Paug-Vik Development Corporation
Environmental Services Division
1600 "A" Street, Suite 306
Anchorage, Alaska 99501
Phone: 907-258-1345
FAX 907-222-5423

November 1, 2006

Subject: Letter Report for Third-Party Evaluation of Moonlight Aquifer and Rock Creek Mine,
Nome, Alaska.

Base Map: USGS Nome (C-1) Alaska

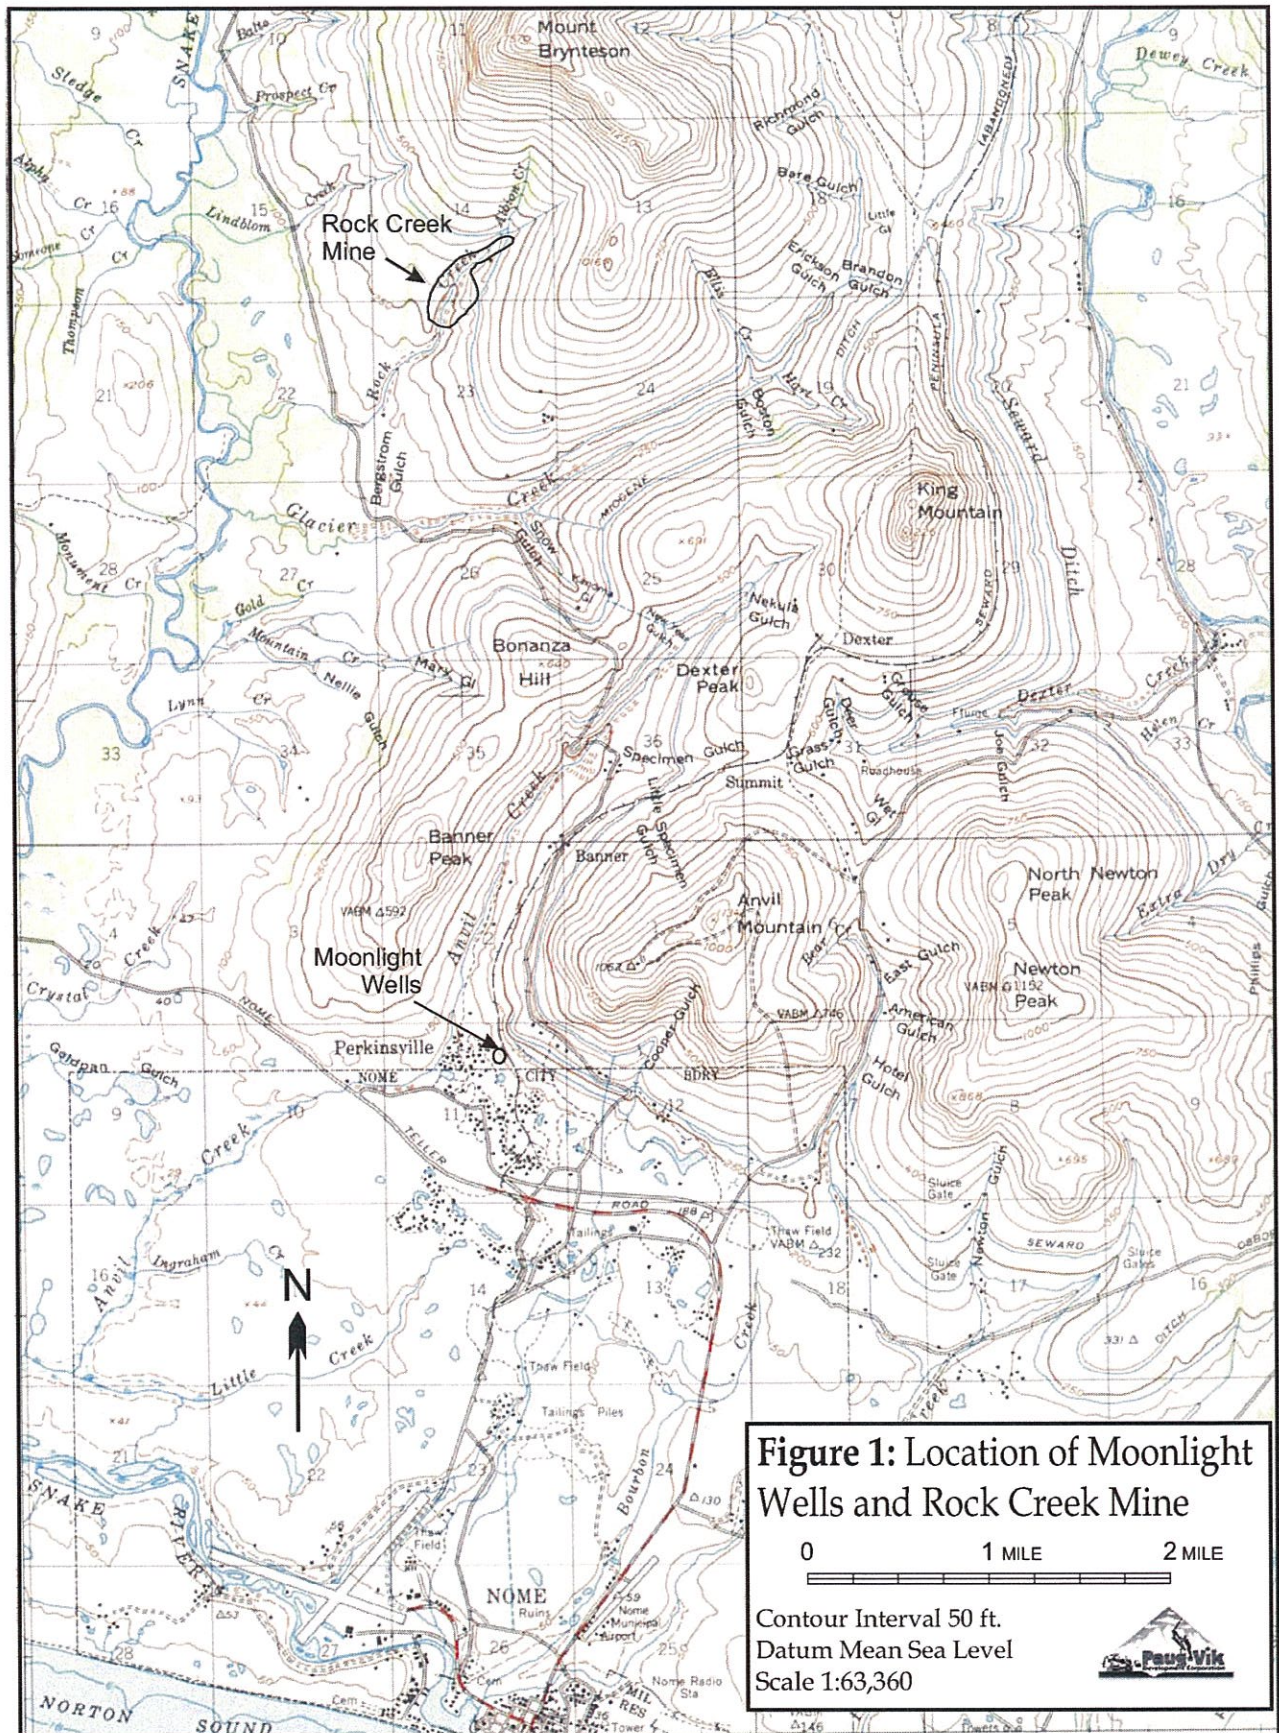
Examination of the topographic map for the Nome area (Figure 1) shows that considerable local topographic relief is present in the area. A local topographic divide is present between the mine site and Glacier Creek. A major divide is also present between Glacier Creek and Anvil Creek, rising to an elevation of over 500 ft above msl. Anvil Creek is incised deeply into the landscape, occurring at an elevation of approximately 100 to 250 ft above msl in its lower reaches prior to flowing out onto the coastal plain near the Nome-Teller highway. The Moonlight wells are at altitudes ranging from 140 to 160 ft above sea level.

These differences in elevation create local groundwater flow system divides. There are two topographic divides and two major streams separating the Rock Creek Mine from the Moonlight wells. Assuming that the water table is a subdued replica of the topography, this means that there are likely four groundwater flow system boundaries (one at each topographic divide and one at each stream location) that separate the Rock Creek Mine from the Moonlight wells. These groundwater flow system boundaries likely extend to depths of at least several hundred feet below sea level. These flow system boundaries, which are oriented transverse to a direct line between the Rock Creek Mine and the Moonlight wells, form effective hydrodynamic barriers to shallow groundwater flow and confirm that groundwater from the area of the injection wells should flow towards the Snake River.
